Addendum # 001

TENDER NUMBER: 652-2020-01

Outdoor Play Space Project

St. Matthew Catholic School

300mm CATCH BASIN

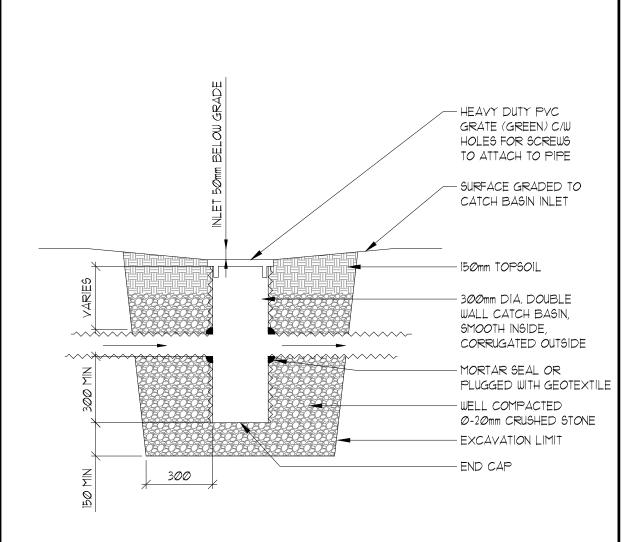
Drawing "300MM Catch Basin" has been included as part of this addendum.

- Q2: In Section A item 1.4 Drainage: Please provide better detail on CB and the picture doesn't provide distances apart, distance from asphalt etc. Having hard time sourcing 300mm CB do you want round or square, is a 18" or 24 " sufficient.

A2: Refer to the "300 mm Catch Basin" detail included in this addenda. The catch basins are located 28,700 mm apart and adjacent to extended asphalt. CB to be 300 mm round drainage grate.
